**ENVIRONMENTAL RESTORATION  
RFCA STANDARD OPERATING PROTOCOL  
FOR ROUTINE SOIL REMEDIATION  
FY02 NOTIFICATION #02-09  
IHSS GROUP 900-11  
IHSS 112 – 903 DRUM STORAGE AREA**

**October 2002**

Appendix B Responsiveness Summary

**Figure 8**  
**903 Pad Subsurface Cross Section**

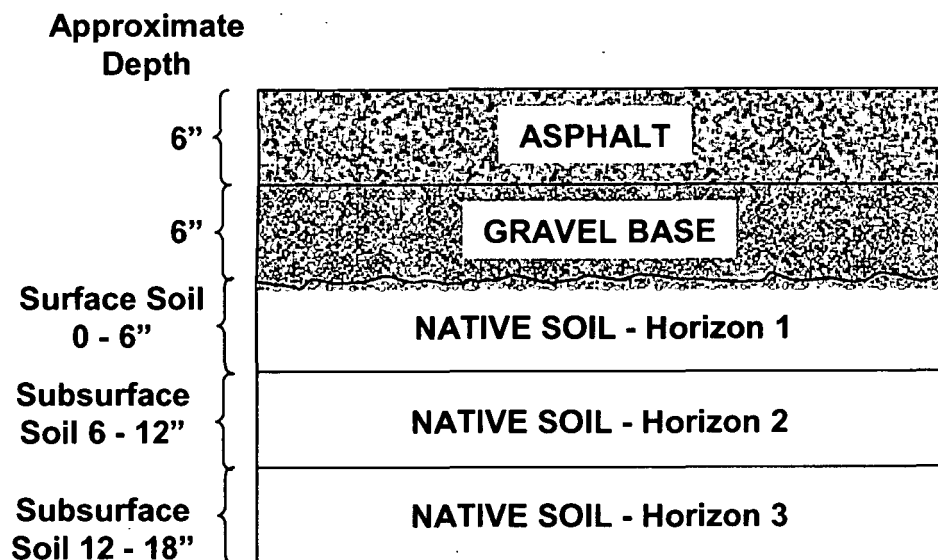
39	<p><b>Section 2.1, Contaminants of Concern.</b> The last sentence of the second paragraph makes reference to Figure 8 (subsurface cross-section), which is actually Figure 9. Suggest that the Figures be switched in order to flow with presentation of information.</p> <p><i>Response: Done</i></p>	No additional response is required.
40	<p><b>Section 2.1, Contaminants of Concern.</b> Paragraph 3 requires reference to supporting documentation if there is no intent to present a summary of the VOC data. To address community and agency concerns regarding VOCs, CDPHE suggests incorporation of a summary of VOC results found in the unsaturated interval (less than 15 feet) with comparison to the Tier I and Tier II soil action levels. This could be used as a basis for consultative process should VOC contamination be encountered at levels of concern during implementation of this accelerated action.</p> <p><i>Response: The VOC data is not presented because the accelerated action is for radionuclides in surface and shallow subsurface soil only.</i></p>	No additional response is required.

43	<p><b>Section 2.2, Project Conditions.</b></p> <ul style="list-style-type: none"> <li>Provide a reference to Figure 8 (903 Pad Subsurface Cross Section), once Figure number is corrected from Figure 9 to Figure 8.</li> </ul> <p><i>Response: Done</i></p> <p>CDPHE Response to Response: We do not see that comment was addressed. Please add to third bullet.</p>	<p>The figure number was corrected and correlation to surface and subsurface soil and associated depth was added to Figure 8. Figure 8 is referenced in Section 2.1 and the following text was added to the reference: “asphalt, gravel, and native soil horizons and their correlation to surface and subsurface soil designation.”</p> <p>The reference to Figure 8 was added to the first, second, and third bullets.</p>
44	<p><b>Section 2.2, Project Conditions</b></p> <ul style="list-style-type: none"> <li>Add the dimensions of the site.</li> </ul> <p><i>Response: Done</i></p> <p>CDPHE Response to Response: We do not see that comment was addressed. Please add to first bullet.</p>	<p>The following text has been added “measures 375 by 395 feet and...”</p>

45	<p><b>Section 2.2, Project Conditions</b></p> <ul style="list-style-type: none"> <li>Indicate that the native soil horizons presented in Figure 8 represent the surface and shallow subsurface soil intervals.</li> </ul> <p><i>Response: Done</i></p> <p>CDPHE Response to Response: We do not see that comment was addressed.</p> <p>Indicate that the native soil horizons presented in Figure 8 represent the surface and shallow subsurface soil intervals <u>to clarify cross-reference to use of terms surface/subsurface soil as related to the use of the terms soil horizons.</u></p>	<p>The surface soil depths are directly correlated to Native Soil Horizon 1, and the two subsurface soil depths are directly correlated to Native Soil Horizons 2 and 3 on Figure 8. The following text has been added to Section 2.1 at the reference to Figure 8: “...903 Pad asphalt, gravel, and native soil horizons and their correlation to surface and subsurface soil designations.”</p>

**Figure 1**  
**IA Groups Location Map**

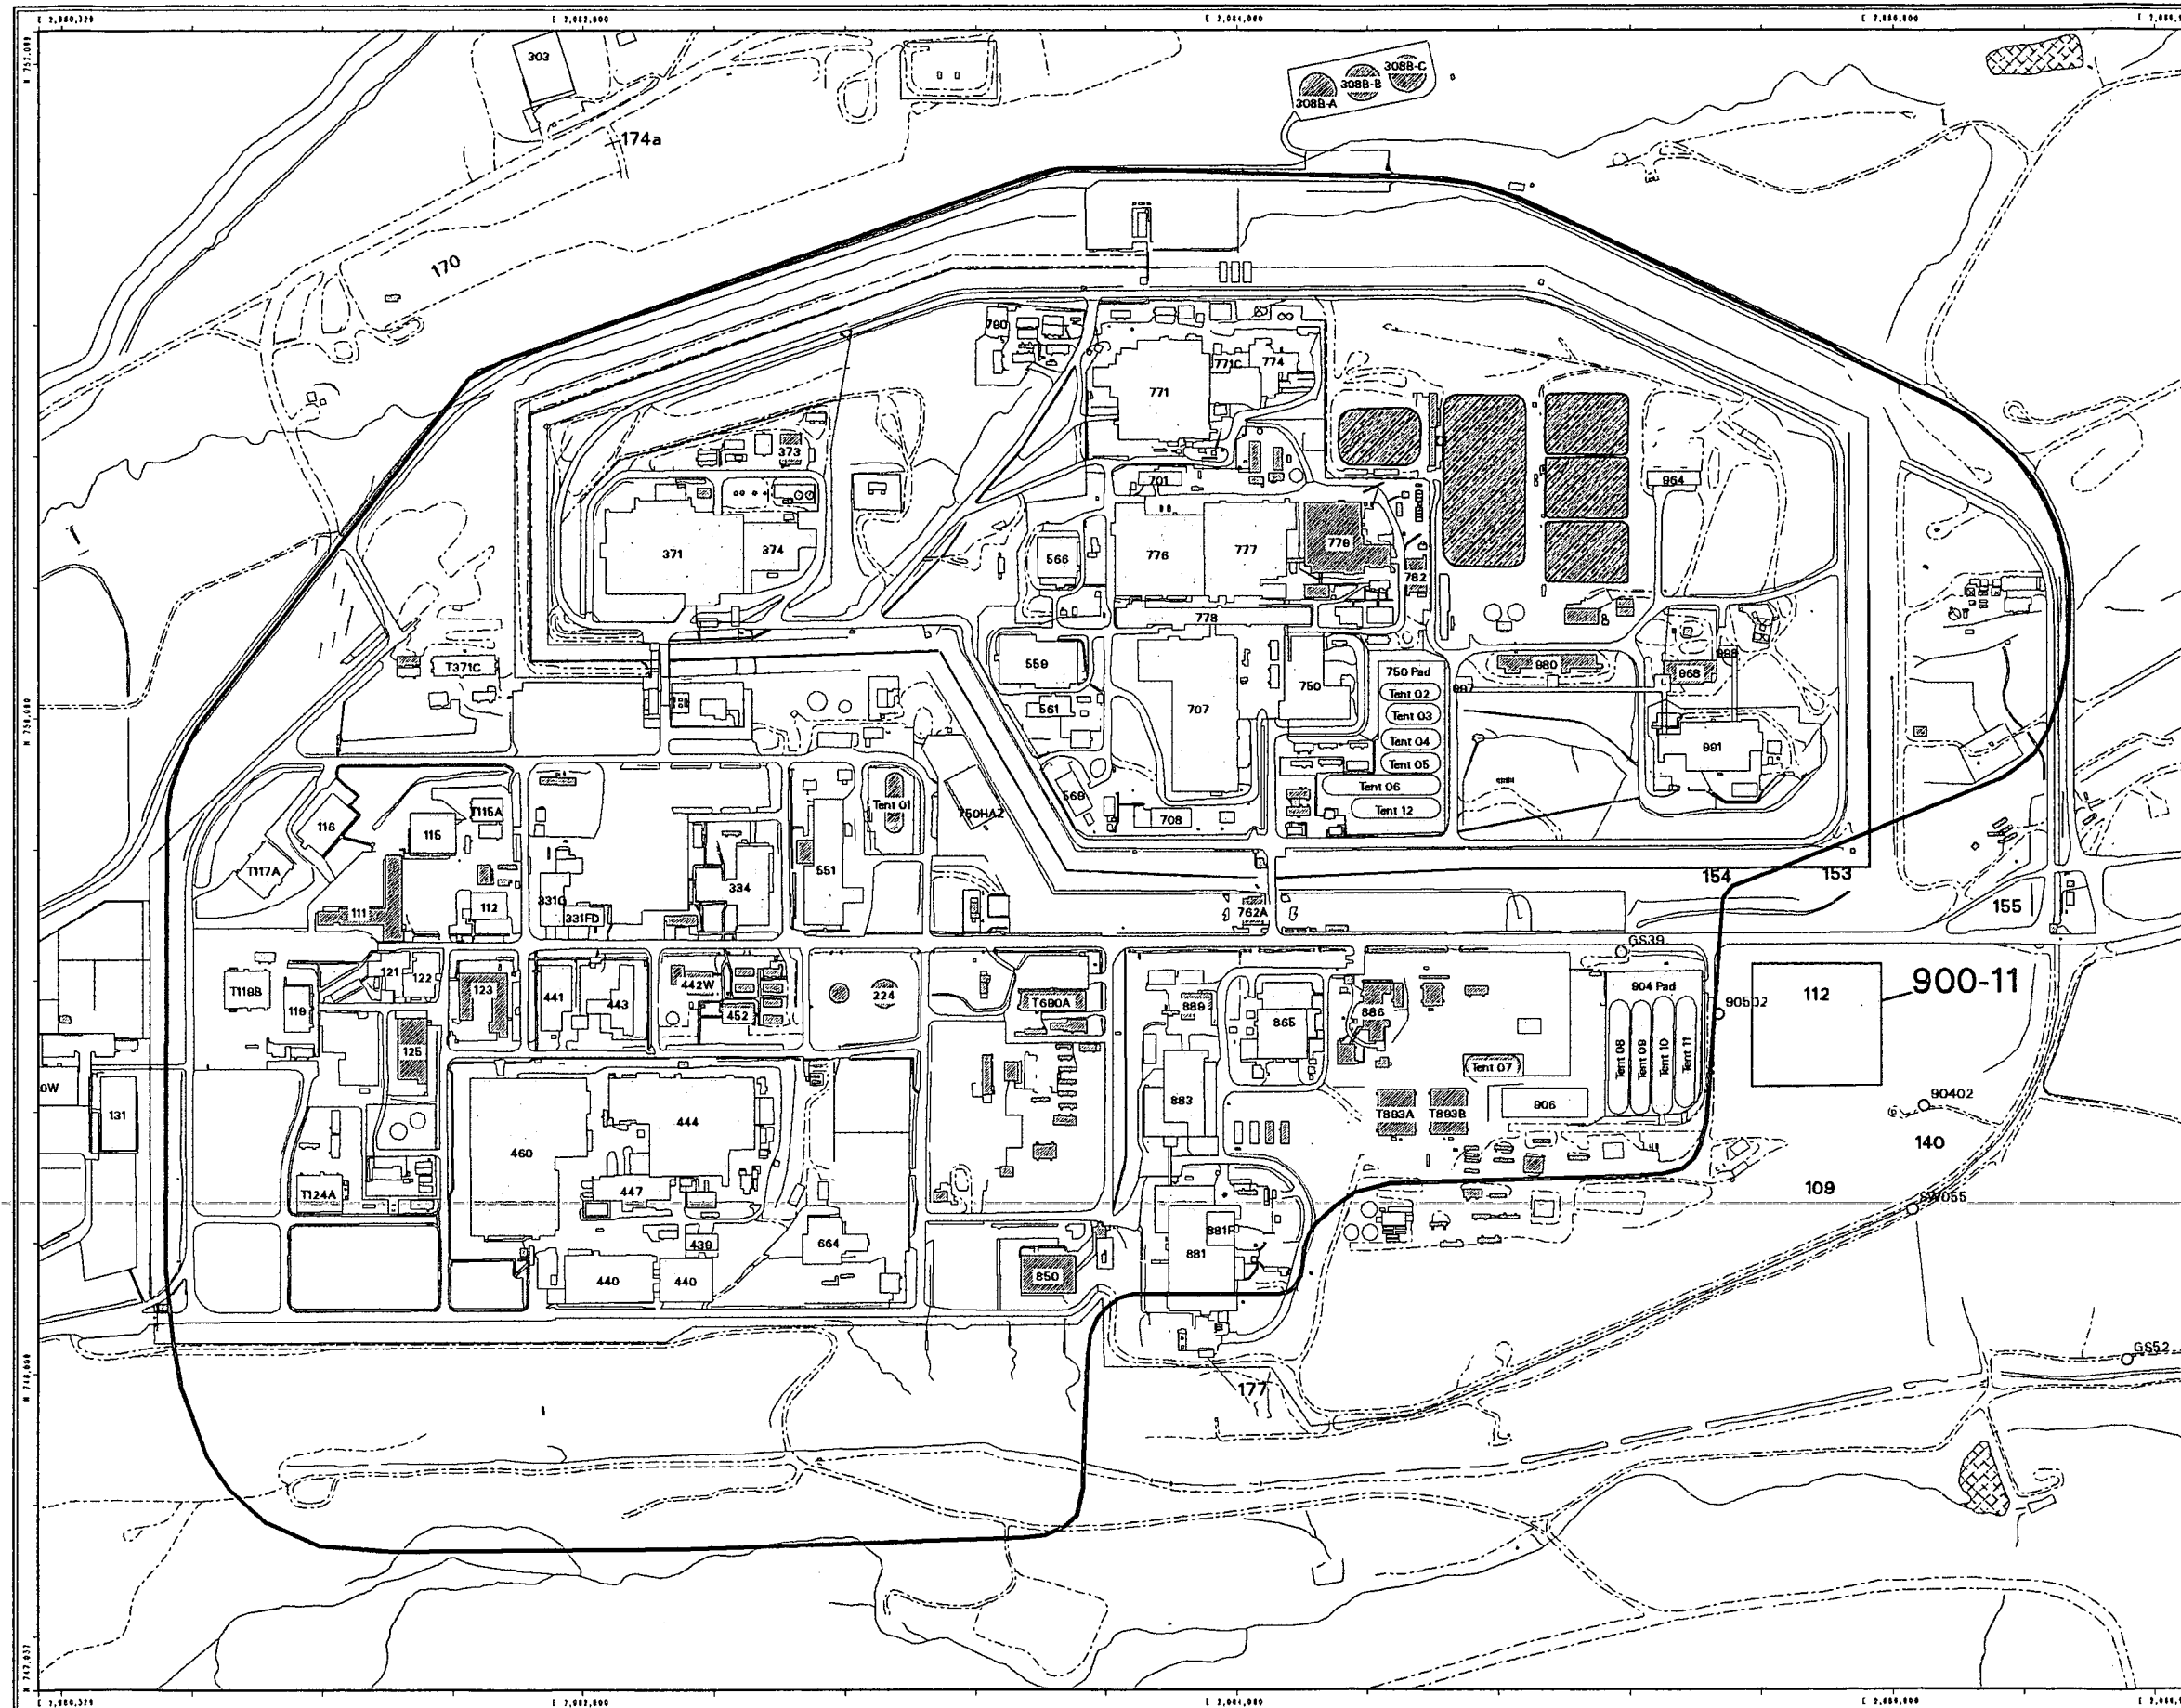
60	<p><b>Section 2.4.3, Surface Water Protection.</b> For surface water results - There are sample results for SW055 in the Quarterly Environmental Monitoring Report January – March 2002 (DOE, May 2002). There was no flow for GS42, GS52, GS53, or GS54 during that time, therefore no results are available. Please add the data from SW055 (Pu-239+240 was 3.160 pCi/l and Am-241 was 0.557 pCi/l).</p> <p><i>Response: SW055 data is being discussed with the Surface Water Group.</i></p> <p>CDPHE Response to Response: Please incorporate the newer data in the new section 2.5.2 and add a clarifying statement that other locations did not yield sufficient water for collection of samples, thus the reason that no data is available. Please show these locations on Figure 1.</p>	<p>Data received from the Site Surface Water Group indicated two samples were collected at SW055 on May 24, 2002, associated with a storm event. Results indicate that americium-241 was present at 0.088 pCi/L, plutonium-239/240 was present at 0.432 pCi/L, and uranium-238 was present at 0.063 pCi/L.</p> <p>Data from the Quarterly Environmental Monitoring Report January – March 2002 (DOE 2002) was not included in the draft Notification because the report stated that there was no flow at this location. The referenced results for SW055 are for a composite sample from May 28, 2001 to May 24, 2002. These data and the data from the May 24, 2002, sampling event were added to Table 4.</p> <p>The following text was added to the end of the third paragraph in Section 2.5.2: “because of drought conditions, there was no water to sample.”</p> <p>The locations were added to Figure 1.</p>

**Figure 4**  
Native Soil Horizon 3  
Approximately 12" to 18"  
Existing Sampling Data  
Greater Than Background  
Means Plus 2 Standard  
Deviations

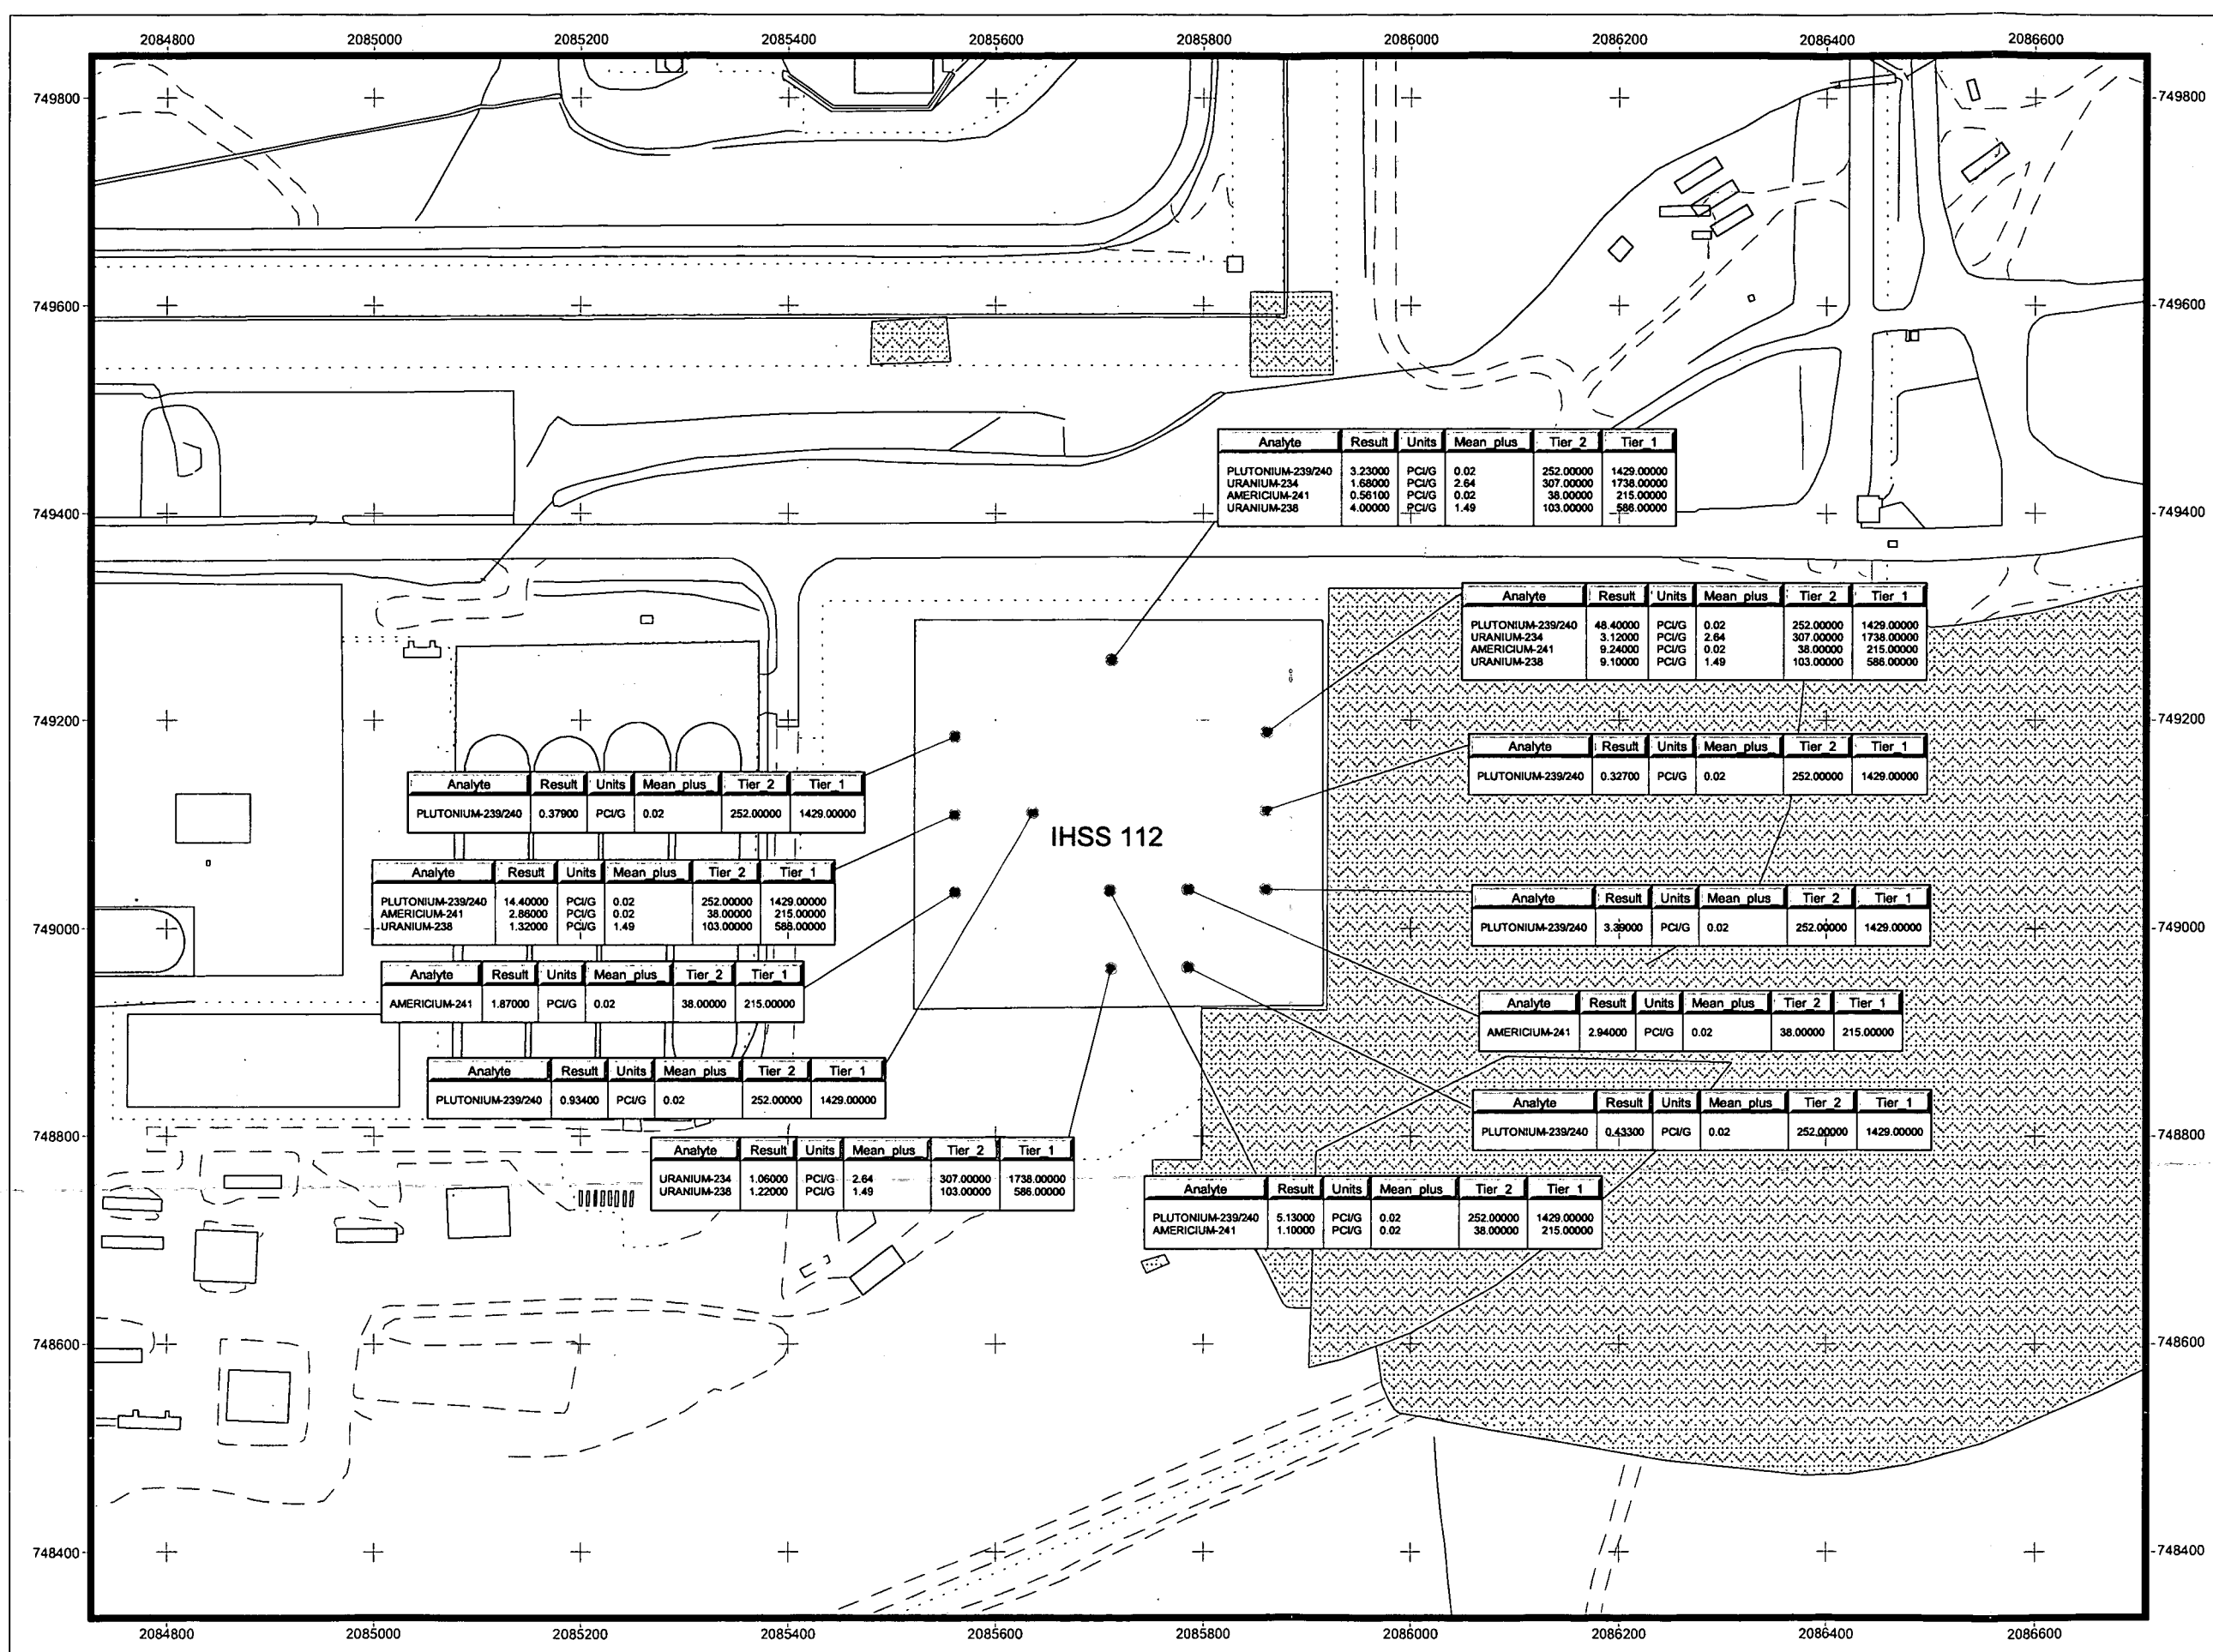
22	<p><u>Section 2.1 – Contaminants of Concern</u></p> <p>In Figure 4 (Native Soil Horizon 3 Approximately 12” to 18” Existing Sampling Data Greater Than Background Plus 2 Standard Deviations), the maximum americium concentration appears to be around 9 pCi/g. As per the June 2000 “Characterization Report for the 903 Drum Storage Area, 903 Lip Area, and Americium Zone” (903 Pad Characterization Report), Section 4.2.1.3, the maximum radionuclide activity at depths greater than 12 inches of native soil is 54 pCi/g of americium (Am) in Native Soil Horizon 3. This concentration for americium is not in the 903 Pad Notification. Does the Site have newer data that show this hot spot does not currently exist?</p>	<p>As shown on Figure 4-13 of the Characterization Report for the 903 Drum Storage Area, 903 Lip Area and Americium Zone (DOE 1999), the Tier II americium exceedance in Native Soil Horizon 3 is in the Lip Area, east of the 903 Pad. This area will be addressed as a separate notification or as part of the 903 Lip Area IM/IRA.</p>
